30 Monument Street Single Family Residence  
Project Summary

## Jeanie Bourke - Re: 30 Monument St. Bp#2014-02773

Address/Location of Construction: 30 Monument Street		
Total Square Footage of Proposed Structure:		same
Tax Assessor's Chart, Block & Lot Chart#      Block#      Lot# 16-E-10	Applicant Name: Brewster Buttfield Address 58 Fore Street City, State & Zip: Portland, ME 04101	Telephone: 207-749-7400 Email: brewster@prospectdesign
Lessee/Owner Name: Rich Robinov (if different than applicant) Address:  City, State & Zip: Portland, ME Telephone 207-747-9084 E-mail:	Contractor Name: Cornerstone Build (if different from Applicant) Address: 100 Congress St. City, State & Zip: Portland, ME 04101 Telephone 207-939-0185 E-mail:	Cost Of Work: \$ C of O Fee: \$ Historic Rev \$ Total Fees : \$ 69.00
Current use (i.e. single family) <small>single family</small> If vacant, what was the previous use? Proposed Specific use: <small>single family</small> Is property part of a subdivision? ___ If yes, please name _____ Project description: This is an addendum to permit number BP# 2014-02773. Addition of finished basement, emergency egress well and details on one hour wall.

A-103

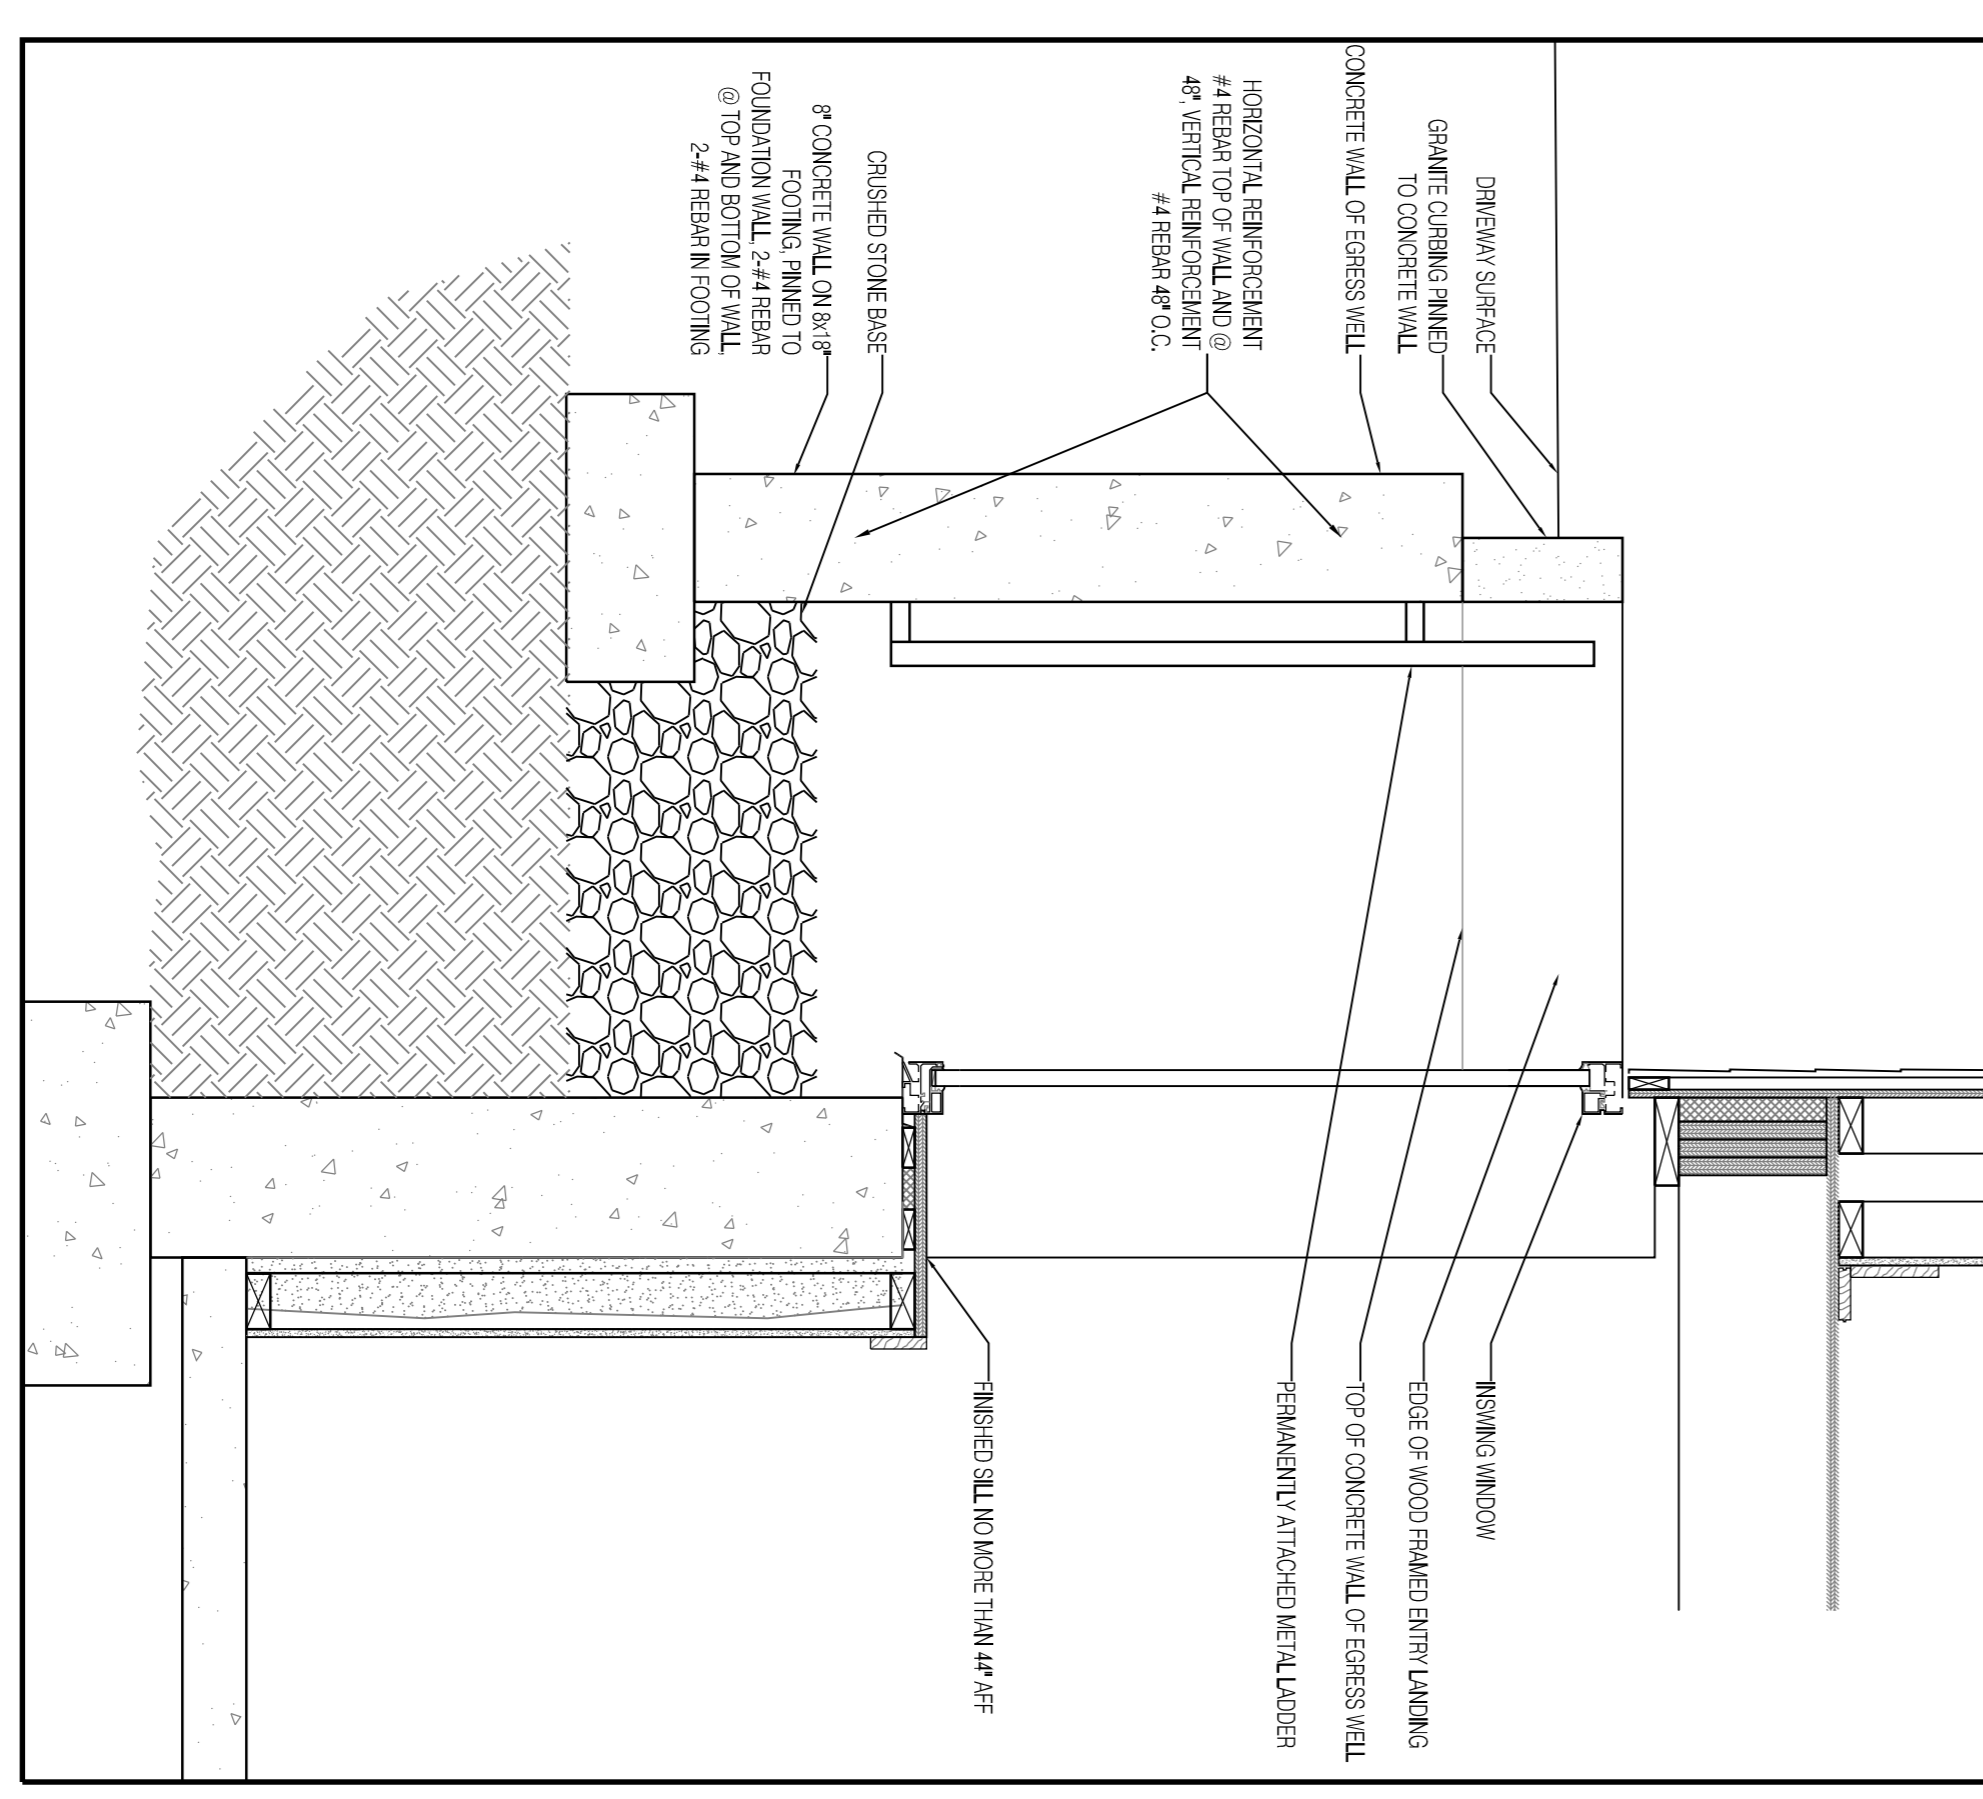
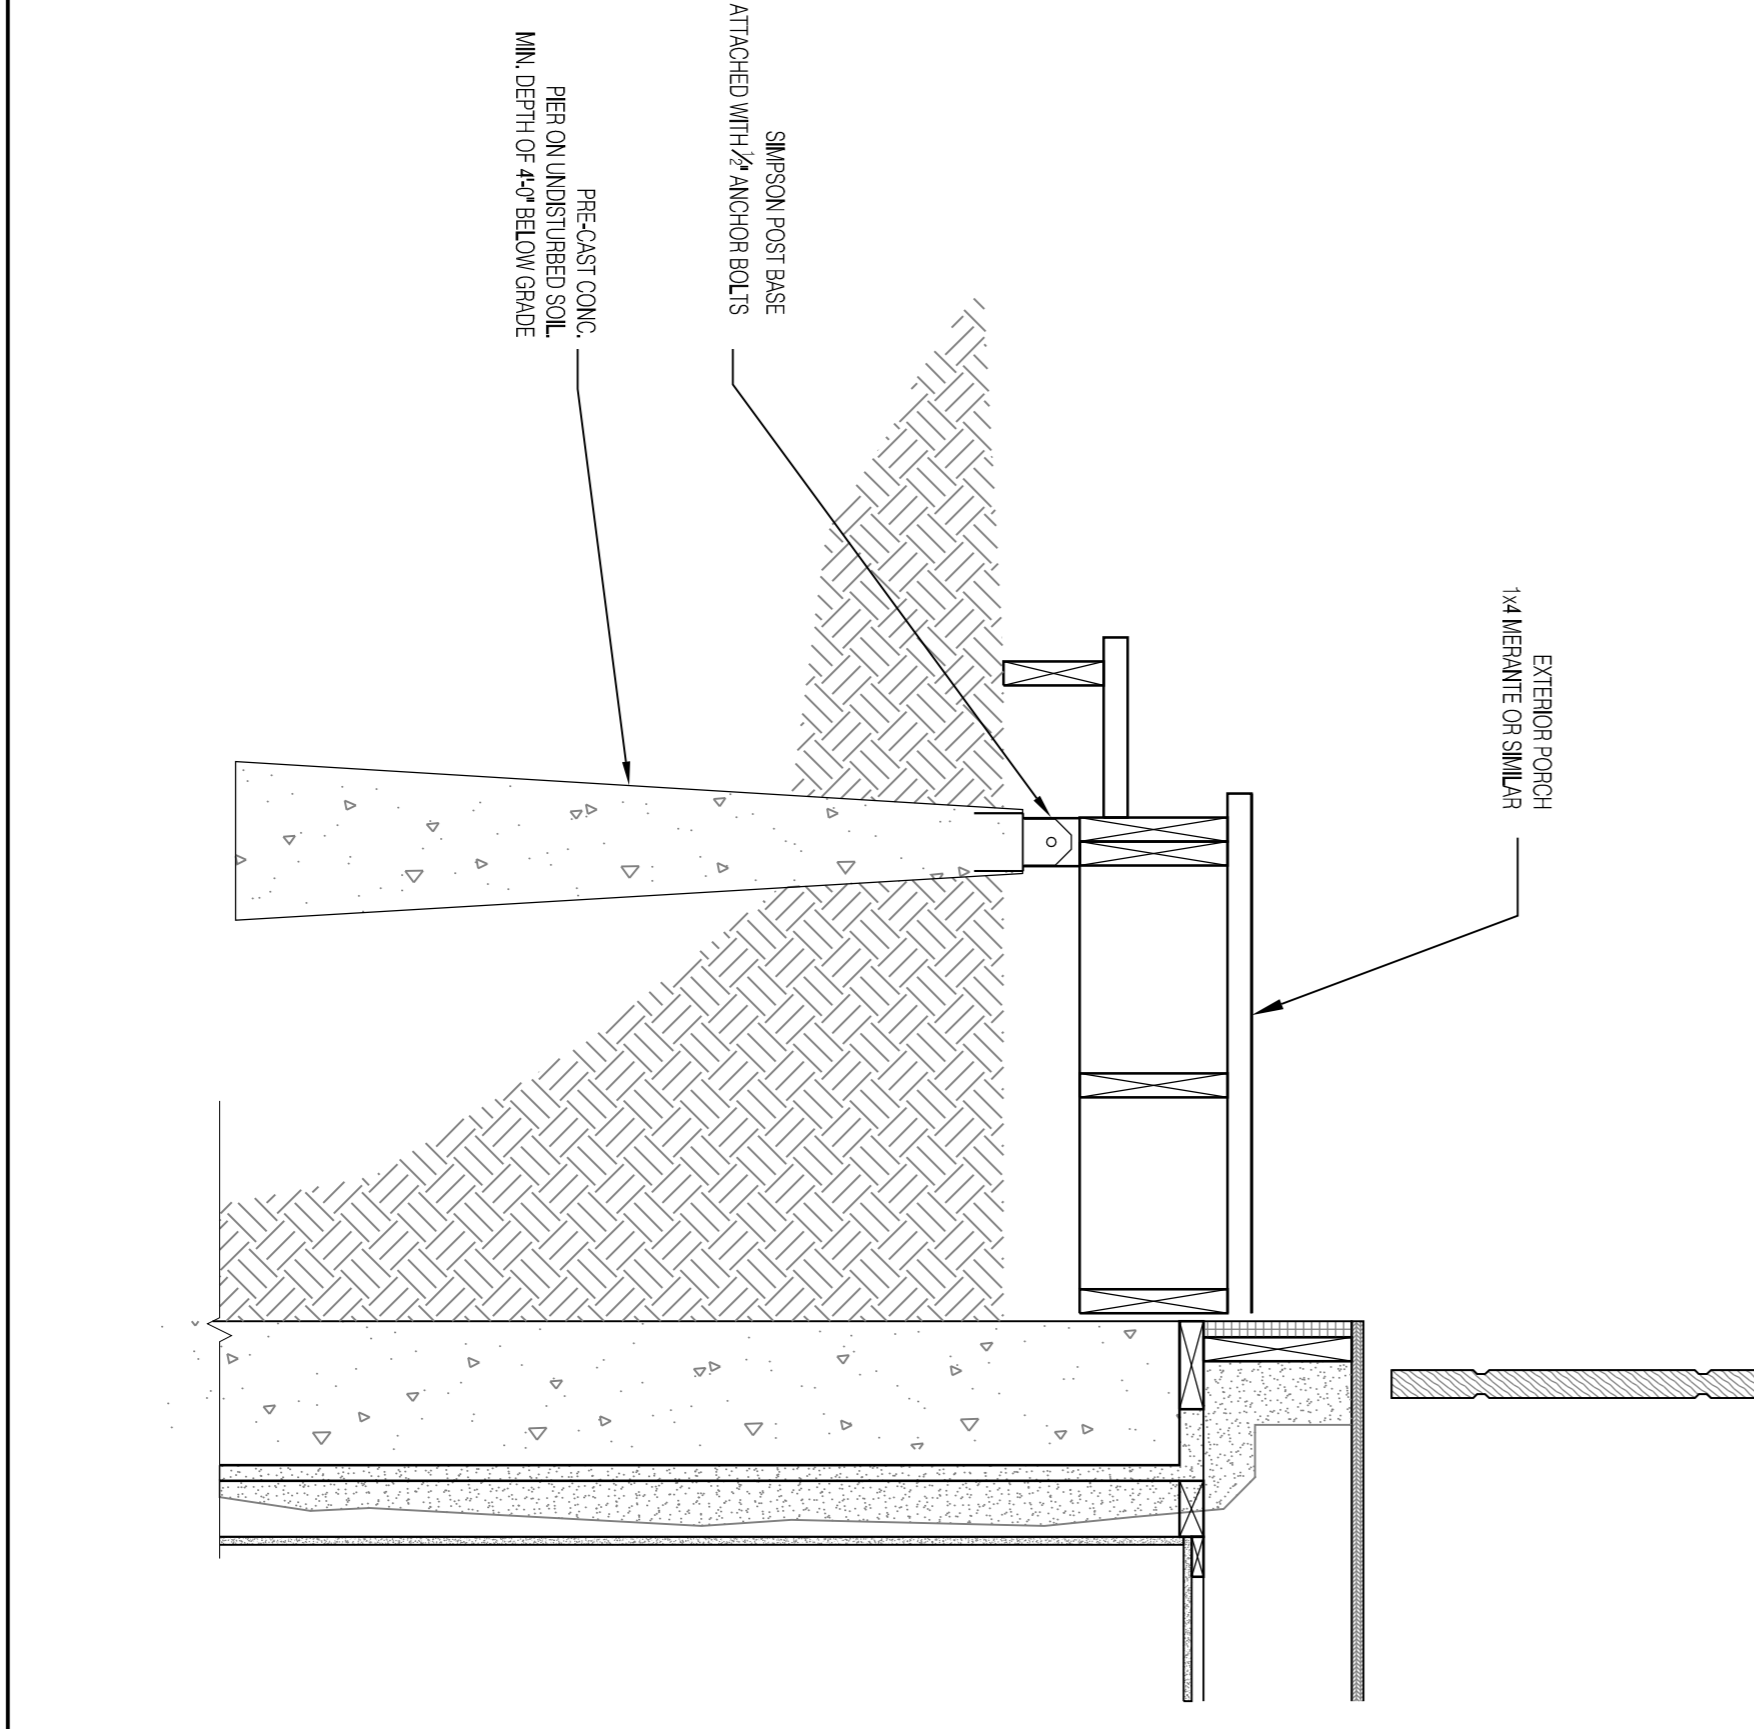
3. An updated plan for the deeper basement is a new sheet, A-103. It shows the required egress well, the stairs to basement instead of a hatch and the required thermal barrier for the insulation. **This, as well as any other changes need to be updated on all associated plans, ie. sections, etc.**

3. Based on the field inspection by George for the footings, it was confirmed with the contractor that the house will have a full basement. If this is correct, an amendment is required for this change and should include the access and emergency escape and rescue opening.
